Department of Energy
Washington, DC 20585

June 2, 2009

YUCCA MOUNTAIN - REQUEST FOR ADDITIONAL INFORMATION (RAI) –VOLUME 2,
CHAPTER 2.1.2, SET 1 (DEPARTMENT OF ENERGY'S SAFETY ANALYSIS REPORT
SECTION 1.3.4, 1.3.5, and 1.11) – Retrieval

Figure 1. Classification of Repository Openings According to Accessibility

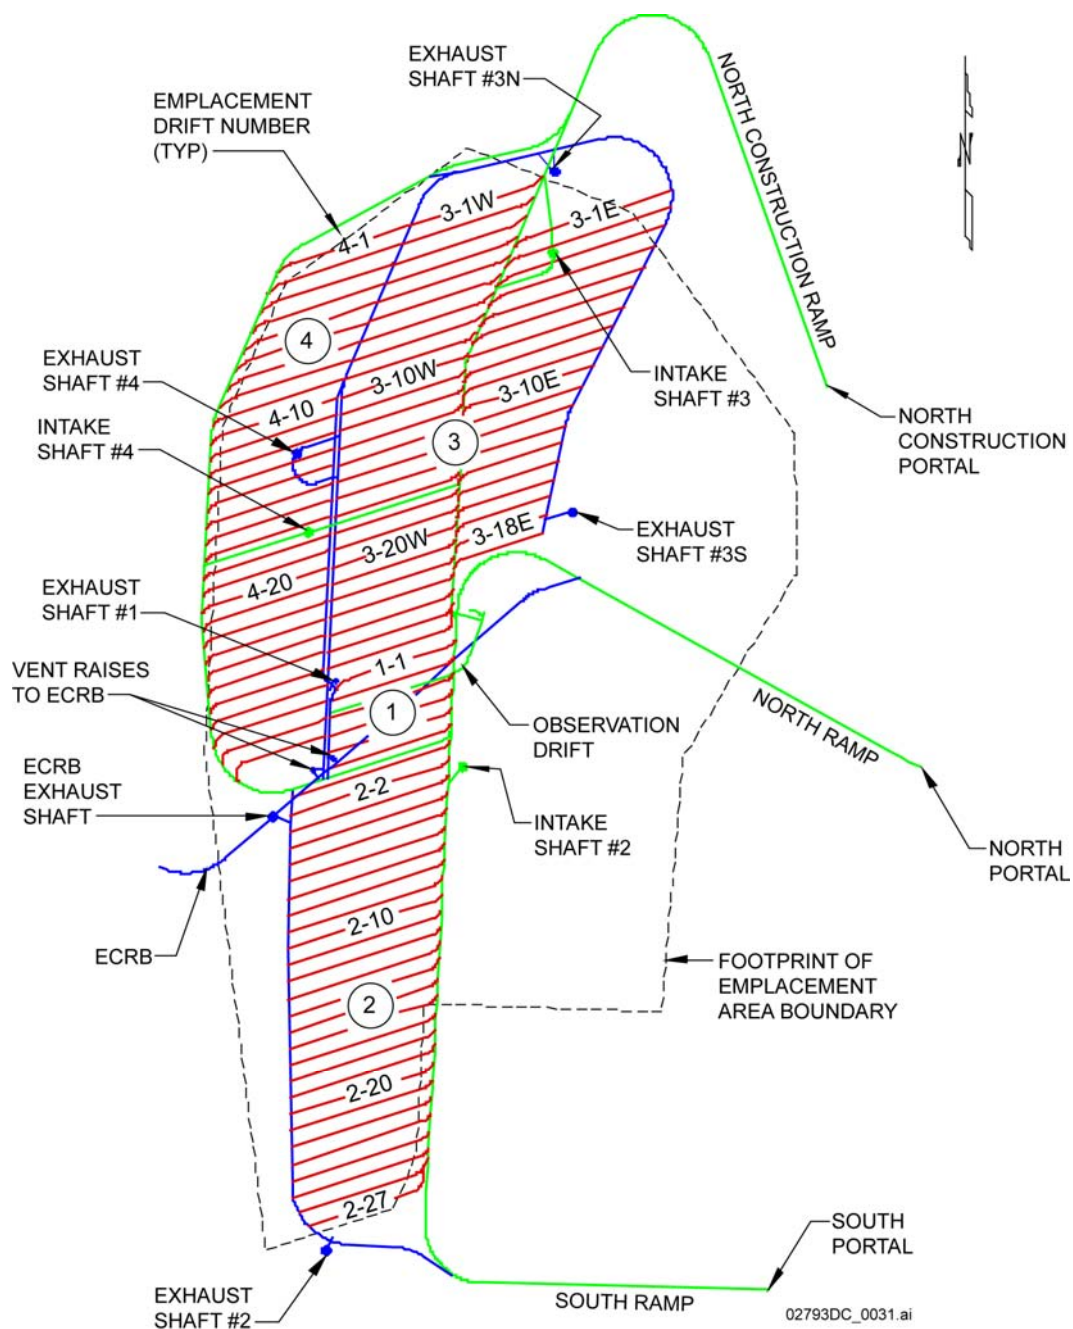
Provide a monitoring plan for the ground support system that explains what will be monitored, frequency of monitoring, criteria for selecting drifts to be monitored, spatial frequency of measurements within the drift, and the technical approach for processing information collected through monitoring to assess the performance of the ground support system and the need for maintenance to ensure access to waste packages through the preclosure period.

The SAR presents two distinct approaches for inspections, monitoring, and maintenance of repository ground support systems, depending on the classification of the repository openings for personnel accessibility as shown in Figure 1. These classifications are based on the expected thermal and radiation environments for the different openings. The specifics of the RAI are addressed separately for both accessible and inaccessible openings. Further differentiation is made in the response between those accessible and inaccessible openings directly used for a potential waste package retrieval operation and other repository openings not directly related to retrieval but still needed for support functions (i.e., ventilation). The monitoring and maintenance approaches for both types of openings are based on the robustness and the longevity of the materials selected for the type of opening. Monitoring and maintenance activities in inaccessible openings rely mostly on the use of remotely operated vehicles. Conceptual designs for two of these remotely operated vehicles are shown in Figures 2 and 3.

Figure 1. Base Frame Secured to Longitudinal and Transverse Beams

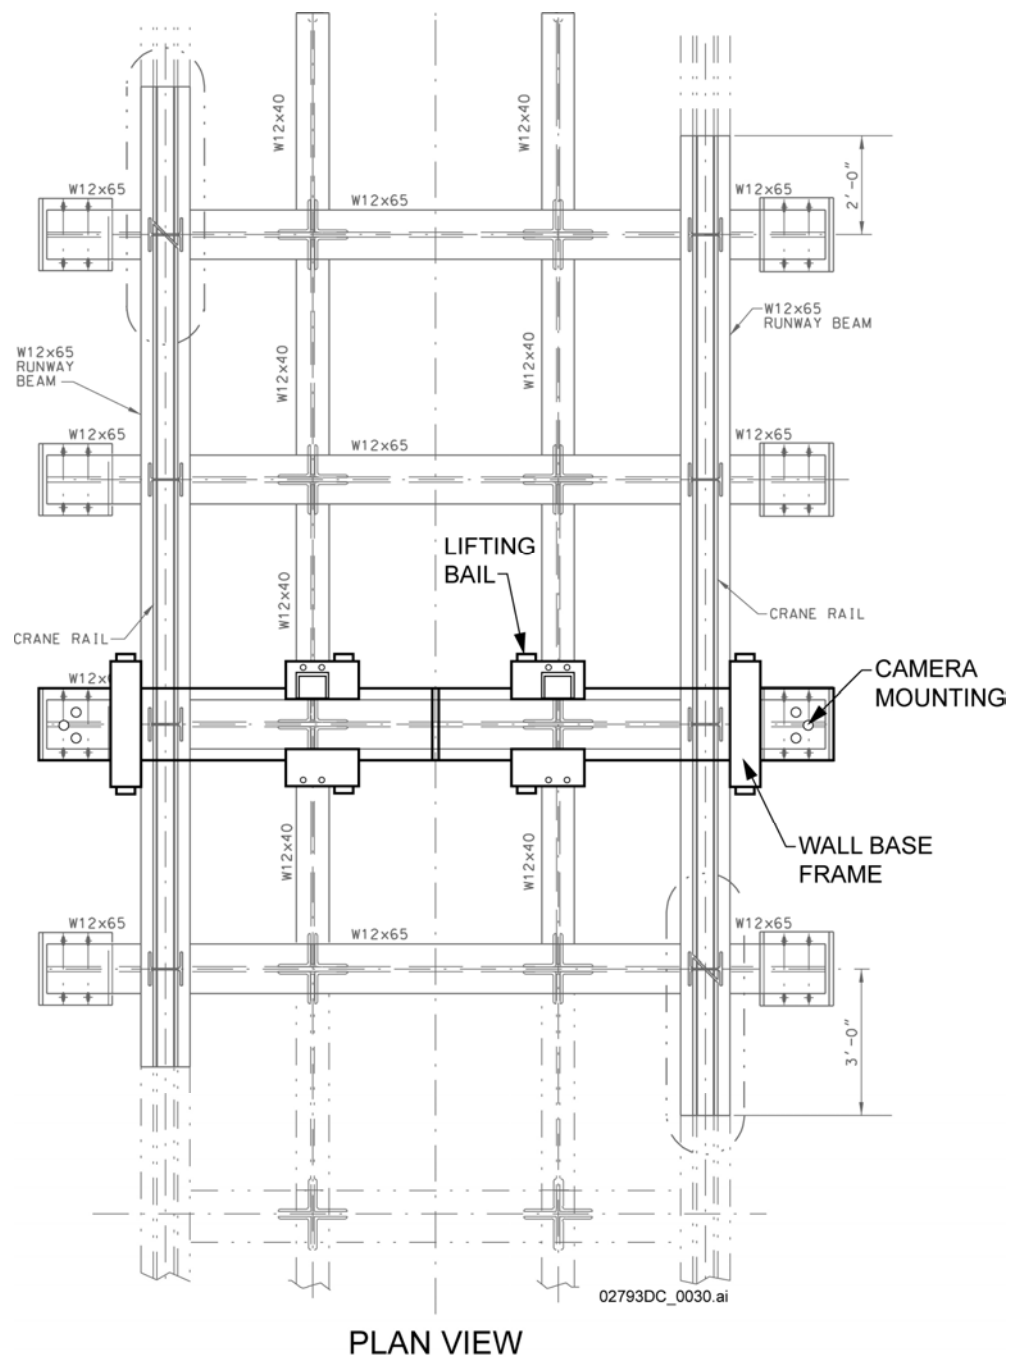
Describe how a temporary shield wall will be installed using the Multipurpose Recovery Vehicle (MRV). (Section 3.3.4 of BSC 2007b).

The wall base frame would be secured to the transverse and longitudinal beam using the torque wrench while being monitored via the cameras. The wall base frame is shown in Figure 2. These steps would be repeated for the installation of the second half of the wall base frame. Once installation of the wall base frame has been completed, the MRV would be readied for the next operation.

Figure 1. Rock Rubble Volume of 6.25 m³/m with Waste Package Emplaced

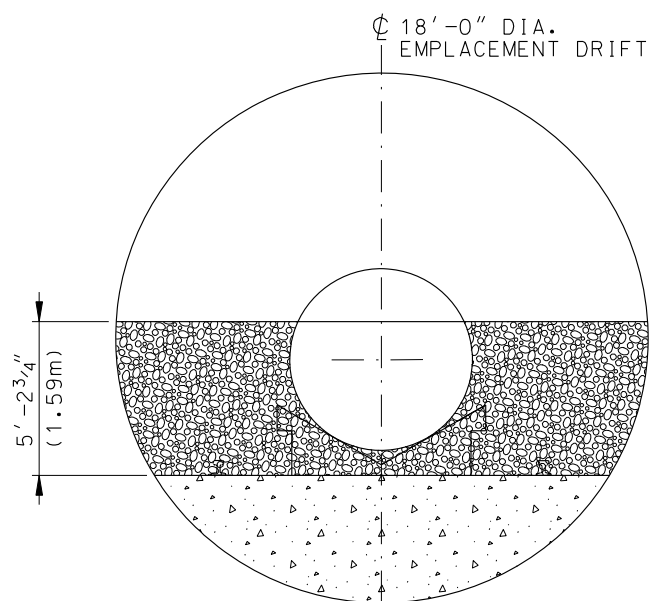
Provide information to a) define limits to waste-package temperature or physical damage that would not impair retrieval and to b) determine if off-normal conditions such as invert failure or rubble blockage of a ventilation conduit could cause the limits to be exceeded.

For the more conservative waste package burial configuration illustrated in Figure 1, analyses performed with ANSYS for a drift air temperature of 100°C , based on a $6.25 \text{ m}^3/\text{m}$ rockfall confined to the excavated emplacement drift diameter and resulting in a waste package burial height of 80%, demonstrate that a maximum OCB surface temperature of 451°C is reached. This estimated peak temperature is less than the 501°C and the 538°C limits that prevent creep rupture of the weldment material and loss of the Alloy-22 structural properties, respectively. The maximum temperature of the OCB is estimated to occur at the bottom of the waste package (BSC 2008, Section 7.2), with other portions of the OCB experiencing lower temperatures due to closer proximity to the free surface of the rubble. The OCB surface temperatures at the side (mid-point) and top of the waste package are estimated as 364°C and 180°C , respectively (BSC 2008, Figure 13).
